Model: AI-C2	Date: 19-Dec-11	No.: RD129001h
--------------	-----------------	----------------

Subject: Firmware Release Note: Fax		Prepared by: T.Hirakawa	
From: 2nd Tech Service Sect., MFP/Printer Tech Service Dept.			
Classification:	<input type="checkbox"/> Troubleshooting	<input type="checkbox"/> Part information	<input type="checkbox"/> Action required
	<input type="checkbox"/> Mechanical	<input type="checkbox"/> Electrical	<input type="checkbox"/> Service manual revision
	<input type="checkbox"/> Paper path	<input type="checkbox"/> Transmit/receive	<input type="checkbox"/> Retrofit information
	<input type="checkbox"/> Product Safety	<input checked="" type="checkbox"/> Other (Firmware)	<input checked="" type="checkbox"/> Tier 2

This RTB has been issued to announce the firmware release information for the **Fax**.

P/N	Description
D6344674	GUIDE:ENTRANCE

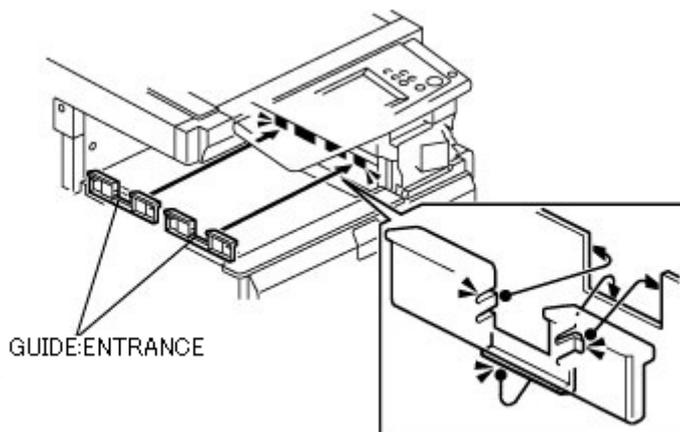
Attach the entrance guide as shown below during the bridge unit installation.

This bridge unit is common with MP C series. However, it is not necessary to attach the GUIDE:ENTRANCE for MPC series. So, please keep the GUIDE:ENTRANCE because it can be used for this model when it was not attached during the bridge unit installation. Otherwise, it may necessary to order this part from your local spare part center.

1.Fax Option (D692)

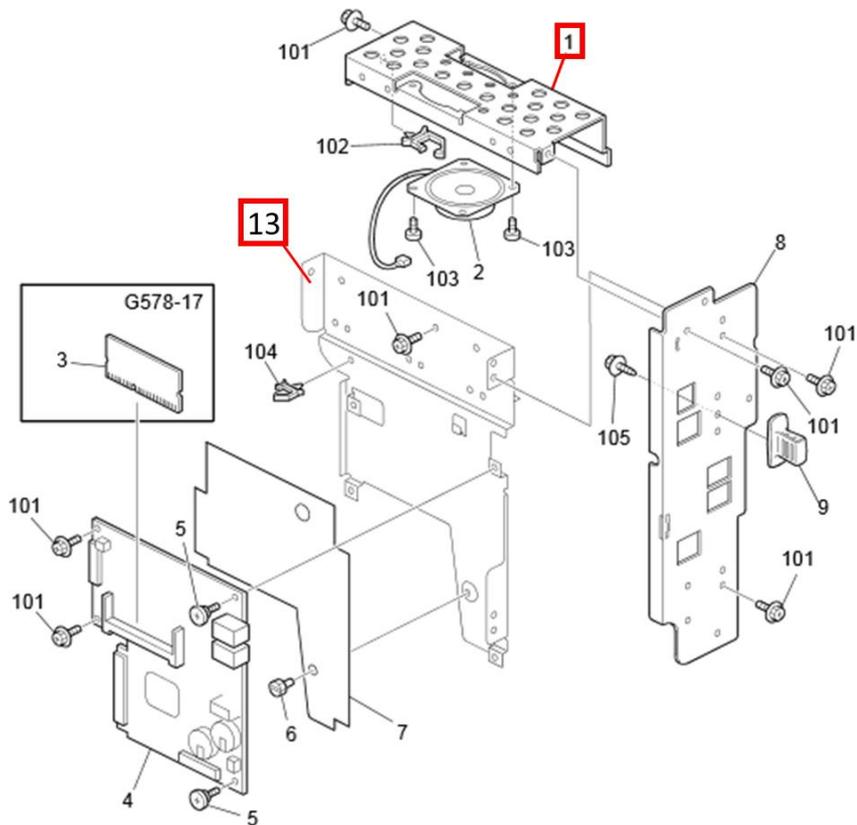
Change/Reason: The following part number is revised from the previous RTB.

Index	New part number	Description	Q'ty	Int	Page	Note
1	<i>D3465734</i>	<i>SPEAKER BRACKET</i>	1		3	-
13	D6295731 D6295720	<i>BRACKET:FAX CONTROL UNIT</i>	1		3	-

Current method:

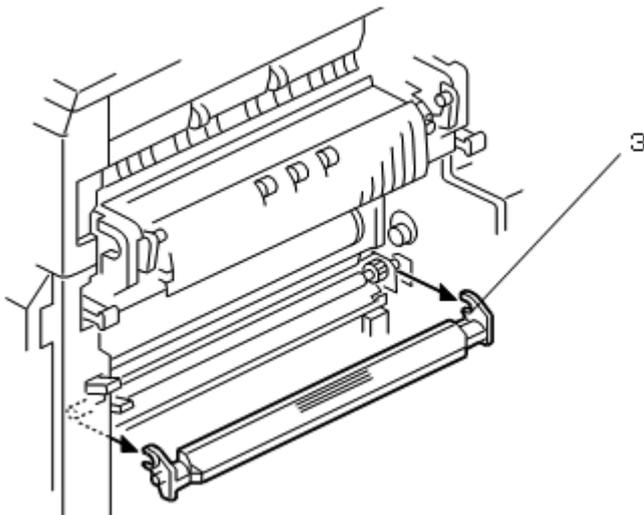
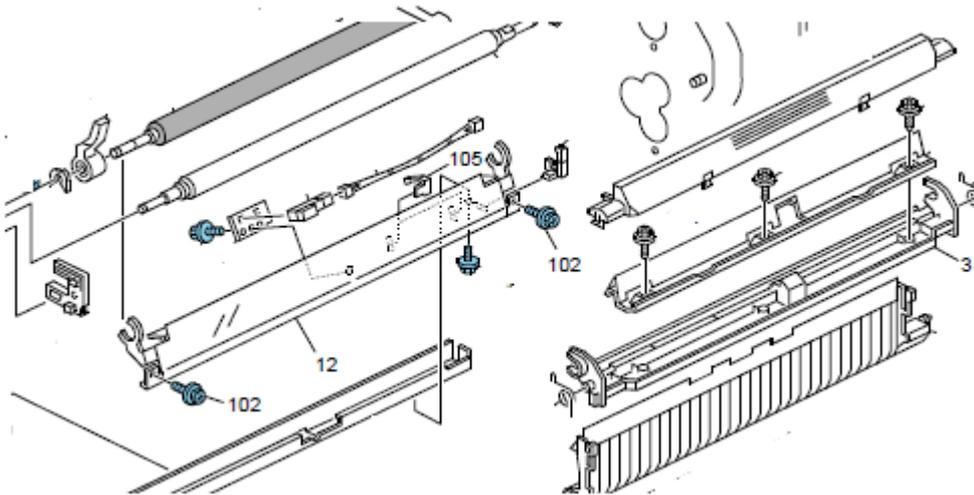
Change: The method for attaching the COVER-PAPER DUST REMOVAL & GUIDPLATE:REGISTRATION:UPPER was changed. **See details below.**

Reason: To further strengthen the integrity of the connection.

The guide plate is fixed by mounting the ends of the shaft and fixing it in place with spring pressure.

- Co-fastening ribs were added to the guide plate (index #3 below).
- This guide plate and registration lower guide plate (index #12) are fastened to each other using a screw (after the shaft is attached).
- The length of this fastening screw was increased from 6mm to 8mm (index #102)

33.Fusing Unit 3 (D129/D130)

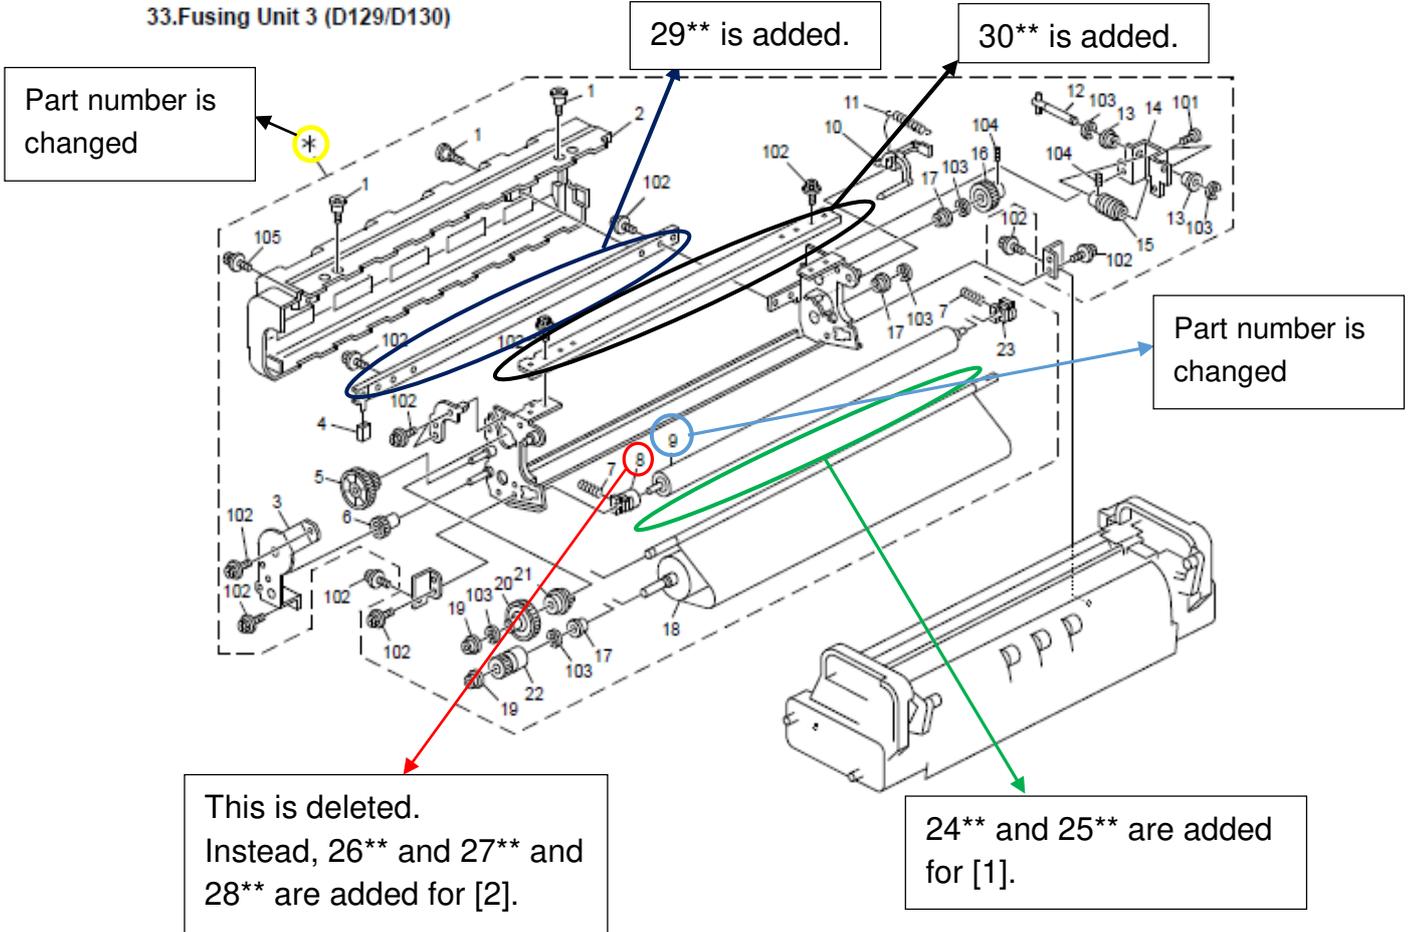
Change/Reason: To prevent the cleaning web from coming loose, the following parts are changed or newly added to the fusing unit.

Please install a new cleaning unit (p/n: D1294304) when a cleaning web issue occurs, because individual parts are not compatible due to modification of a frame on the fusing unit. After that, individual parts can be replaced.

28.PCDU 2 (D129/D130)

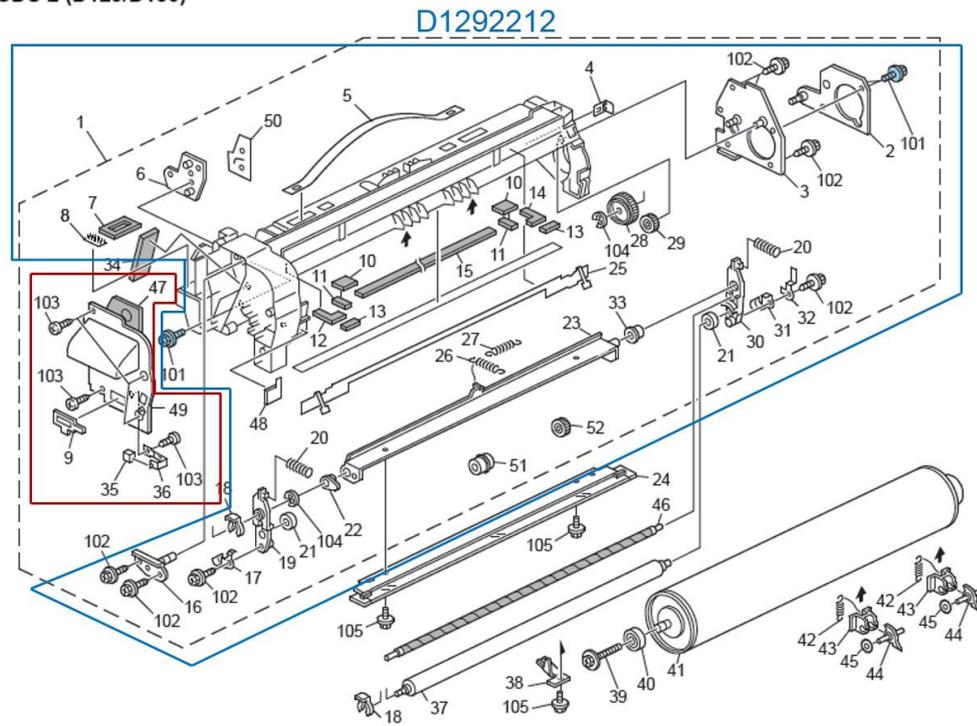
Change/Reason: The illustration shown below was corrected.

Note: The correct outline for P/N D1292212 (index #1) is shown in blue. The parts in the area enclosed in red are registered separately.

51.Controller Section 2 (D129/D130)

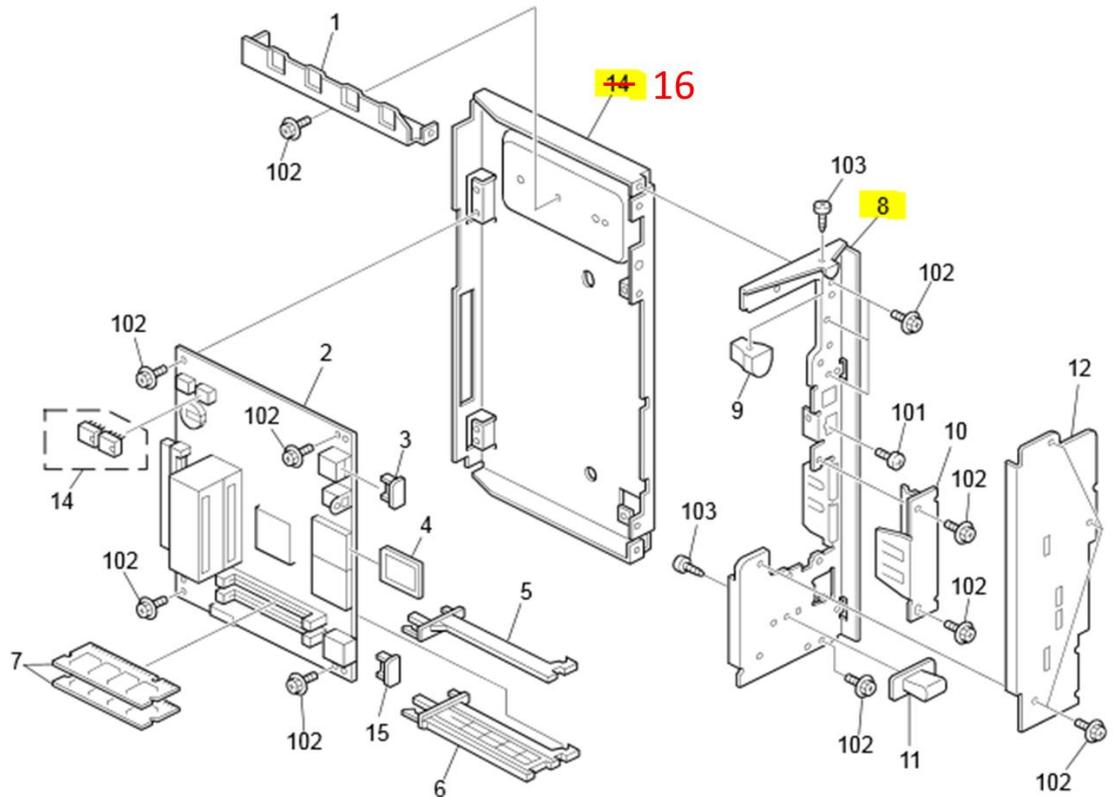
Change/Reason: The following parts were missing from the Parts Catalog.

6.Original Feed 1 (D129/D130)

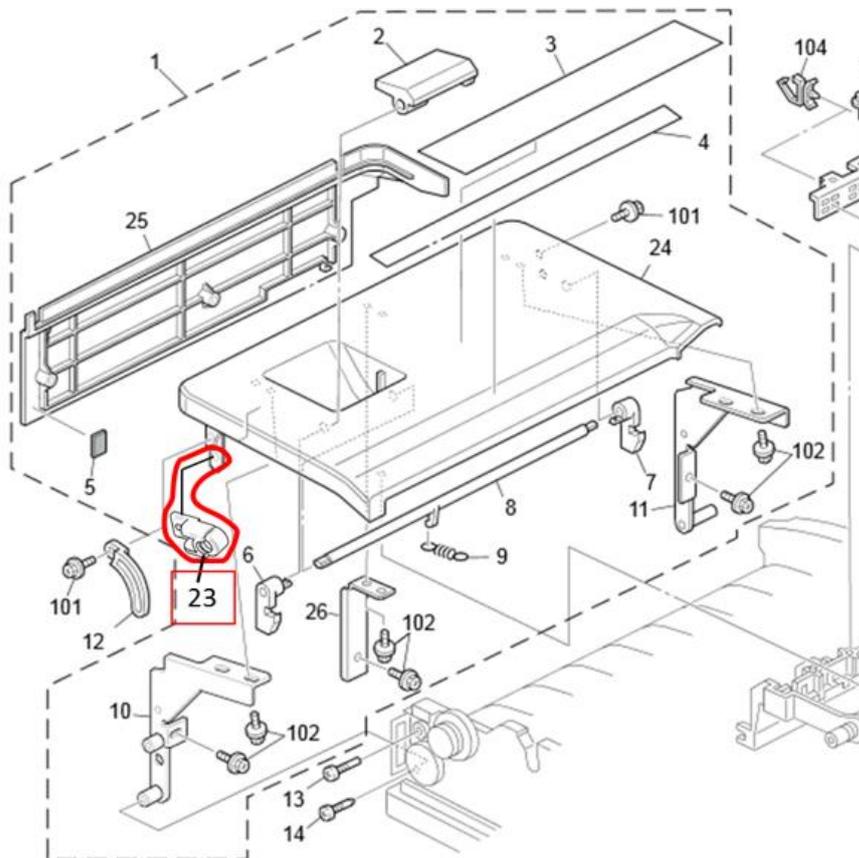
As per field request, the following part was newly added as a service part.

27.PCDU 1 (D129/D130)

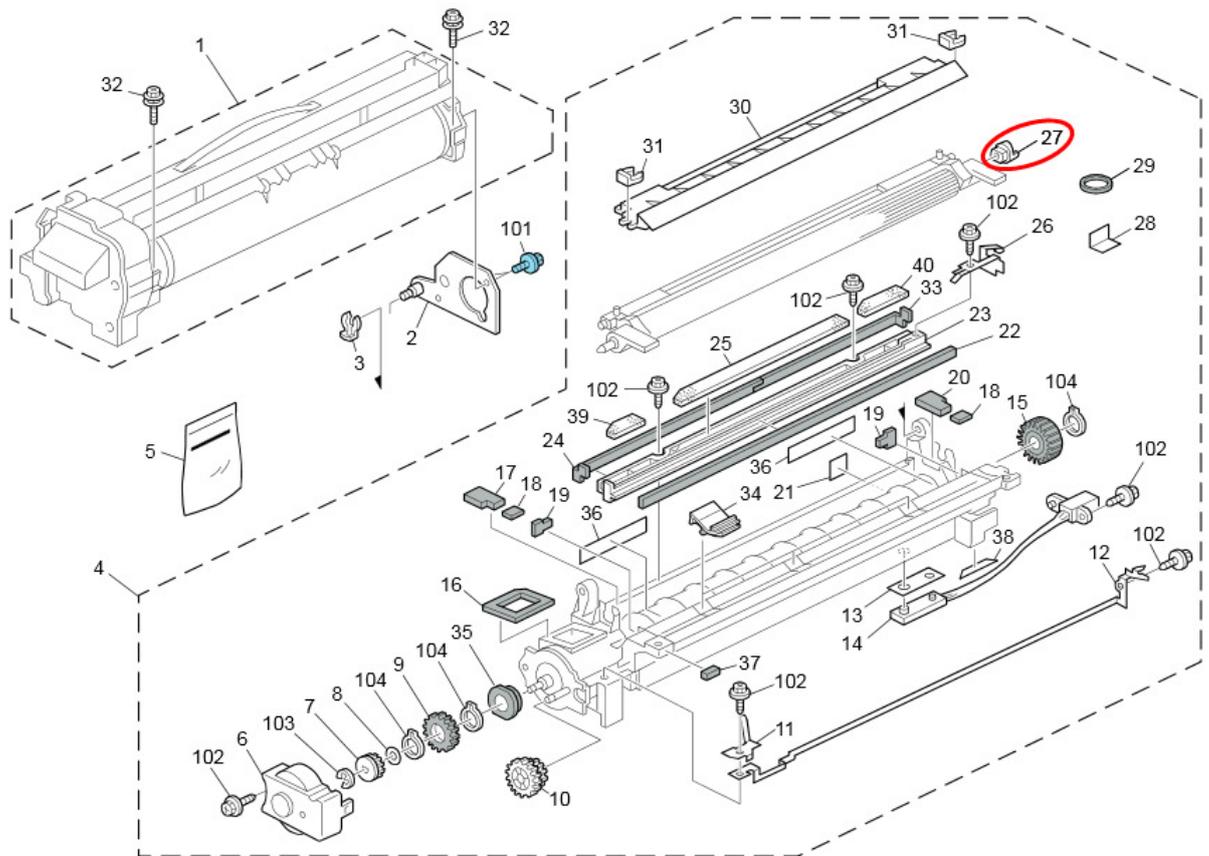
As per field request, the following part was newly added as a service part.

29. Transfer Belt Unit 1 (D129/D130)

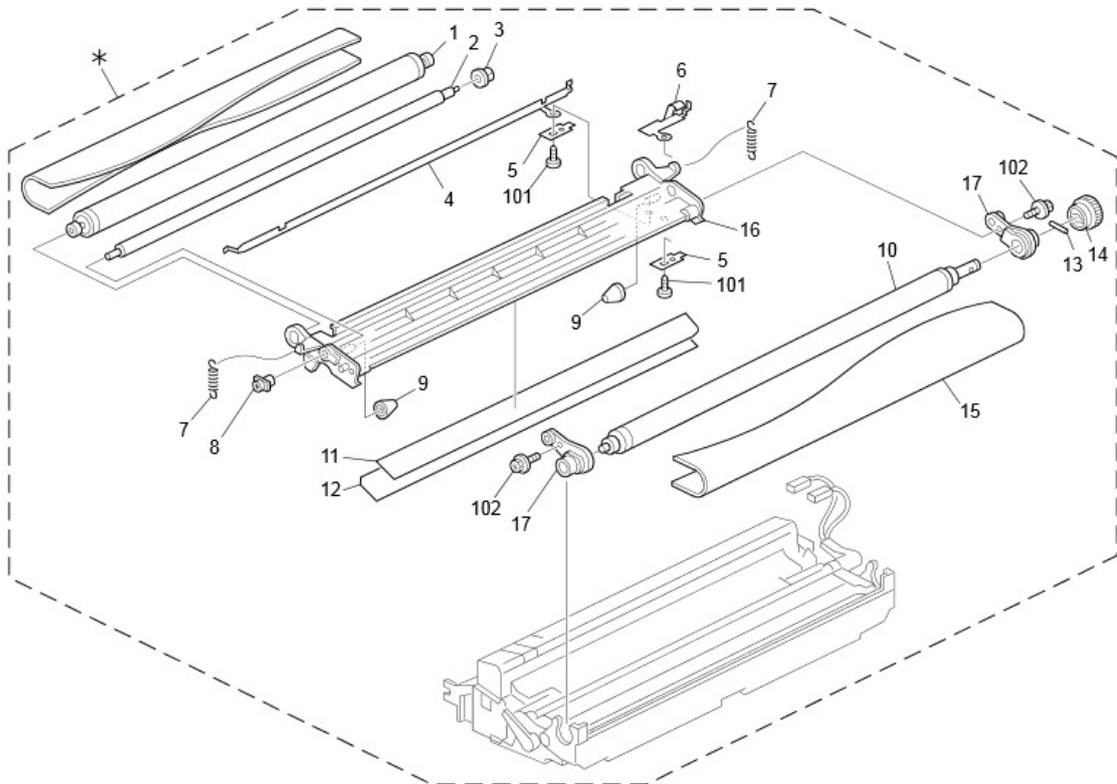
Old part number	New part number	Description	Q'ty	Int	Page	Index	Note
D0093806	D0093808	TRANSFER UNIT:EXP:ASS'Y	1		69	*	-

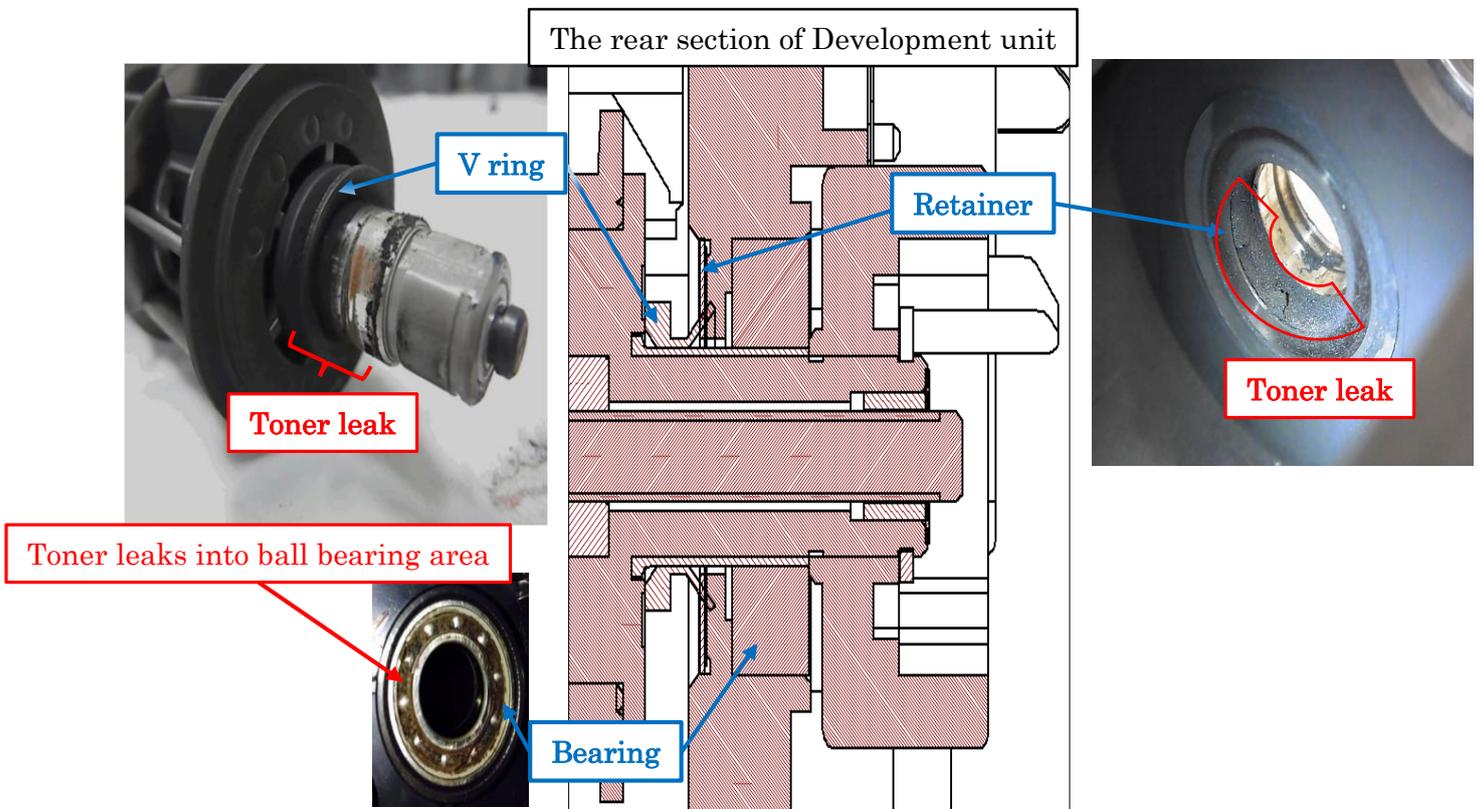
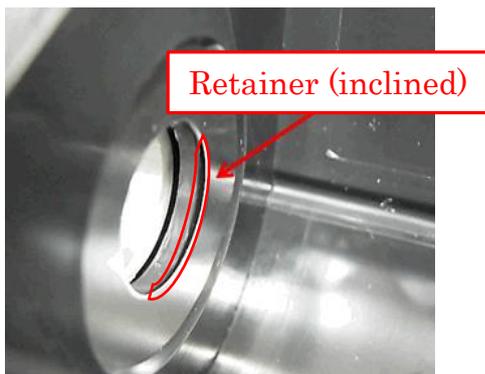
SC324 (Development paddle motor error) or noise occurs.

The retainer is inclined (see photo), allowing toner to leak into the bearing area of the development unit. This increases the mechanical load on the paddle motor, resulting in the SC and/or noise.
